<b style="color: red;">Vision Inspection Ltd.		Product Evaluation Report	
China Office Tel: +86 755 29792782 & 29792783		Report No 2333PER130607V1	Page 1 of 13
Fax: +86 755 29792781		e-mail: simon@visioninspection.com.cn

Order Information			
Customer	xxx	Model No	xxxx
Supplier	xxx	Model No	xxxx
Sample Status	1 st (2 pcs)	Description	Convection Heater
Safety Standard	<input type="checkbox"/> CE / <input type="checkbox"/> BS / <input checked="" type="checkbox"/> SAA / <input type="checkbox"/> UL / <input type="checkbox"/> CSA / <input type="checkbox"/> T / <input type="checkbox"/>

Photo-28 Poor painting on rear inner buckle position. (can be seen clearly form outer produce)-1

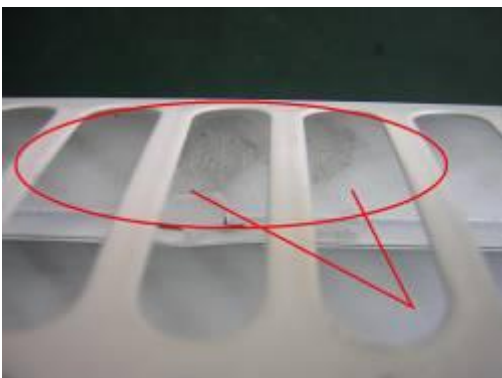
- Coat on outer shell surface bulgy. (1pc) (see photo-25)
- Poor painting of inner bracket buckle position. (2pcs) (see photo-26, 27)
- Poor painting on rear inner buckle position. (can be seen clearly form outer produce) (see photo-28, 29)

NG	Need to add protective plastic on plug pin.	√
	Clarify with customer for the cord length specification.	
	Clarify with customer for the logo requirement.	
	Clarify with customer color of product.	
NG	Need to improve the coat spraying on outer shell.	√
NG	Need to improve the coat spraying on outer shell.	√
NG	Need to improve the coat spraying on outer shell.	√
NG	Need to improve the coat spraying.	√

Photo-38 Screw gets into the mica plate, and cause the mica plate loose out.

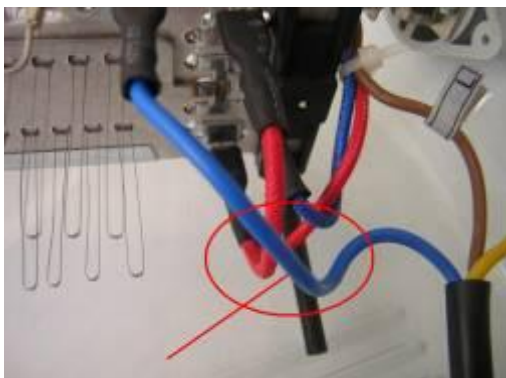
• Screw gets into the mica plate, and cause the mica plate loose out. (see photo-38)	NG	Need to improve. Suggest changing for the screw with cap or adding the washer under the screw.		√

Photo-47 Heating element fixing status: Distance between heating elements not even, distance between some of the heating elements is only 0.8mm.

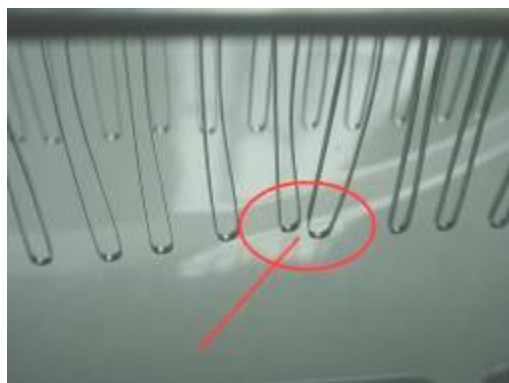
- Inner wiring fixing on inner body status. (see photo-42) 3. Connection terminal fixing on heating element, power switch and thermostat check. (see photo-43~46) 4. Heating element fixing status - Distance between heating elements not even, distance between some of the heating elements is only 0.2-0.8mm. (see photo-47, 48) - Terminal of heating element fixing status check. (see photo-49, 50) 5. Label of power cord fixing status check. - Poor adhesion of label on power cord "L" wire, and it's easy to loose out. (see photo-51) 6. Earth label fixing status check. (see photo-52) 7. Connection wire and terminal fixing status check: - Found that connection wire can not fix in the terminal completely. (see photo-53)	OK OK NG OK NG OK NG	Need To improve. The distance between the heating element should $\geq 4\text{mm}$. Need to improve the adhesive workmanship of label. Need to improve the connecting workmanship.	✓ ✓ ✓

Photo-51 Poor adhesion of label on power cord "L" wire, and it's easy to loose out.

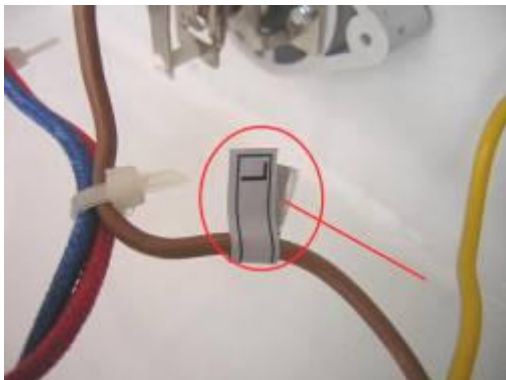
- a. Heating element fixing status: Distance between heating elements not even, distance between some of the heating elements is only 0.2-0.8mm.
- b. Label of power cord fixing status check: Poor adhesion of label on power cord "L" wire, and it's easy to loose out.
- c. Connection wire and terminal fixing status check: Found that connection wire can not fix in the terminal completely.
